PROJECT ADDENDUM #1

- A. Project Name: Fire Station #1 – Oil and Grit Separator Improvements
- B. Owner: The City of Portage

FIRE STATION #1 - OIL AND GRIT
SEPARATOR IMPROVEMENTS

CONCRETE DETAIL

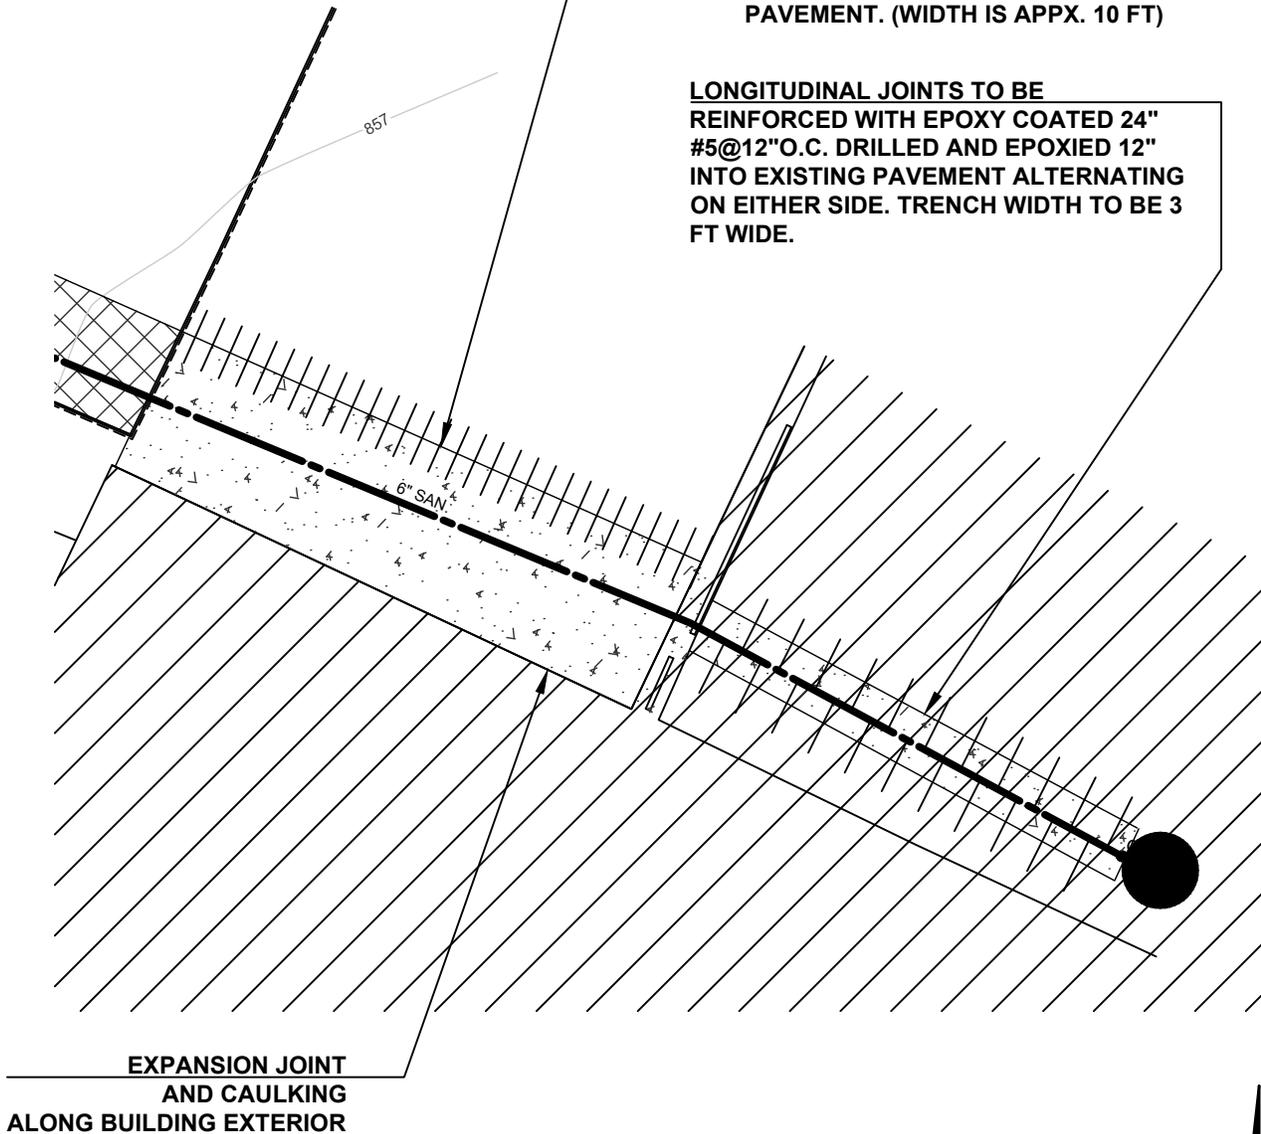
LONGITUDINAL JOINT IN LINE WITH EXISTING EXPANSION JOINT - REINFORCE WITH EPOXY COATED 24" #5@12"O.C. DRILLED AND EPOXIED 12" INTO EXISTING PAVEMENT. (WIDTH IS APPX. 10 FT)

LONGITUDINAL JOINTS TO BE REINFORCED WITH EPOXY COATED 24" #5@12"O.C. DRILLED AND EPOXIED 12" INTO EXISTING PAVEMENT ALTERNATING ON EITHER SIDE. TRENCH WIDTH TO BE 3 FT WIDE.

Lane ties shall be drilled and epoxied along the north longitudinal joint consisting of at least No.5 epoxy-coated deformed bars at least 24 inches long at 12 inches on-center prior to concrete placement. The bars shall be drilled 12 inches into the existing pavement.

Inside the building, the concrete shall have epoxied longitudinal ties on both sides of the removal alternating sides at 12 inches on center.
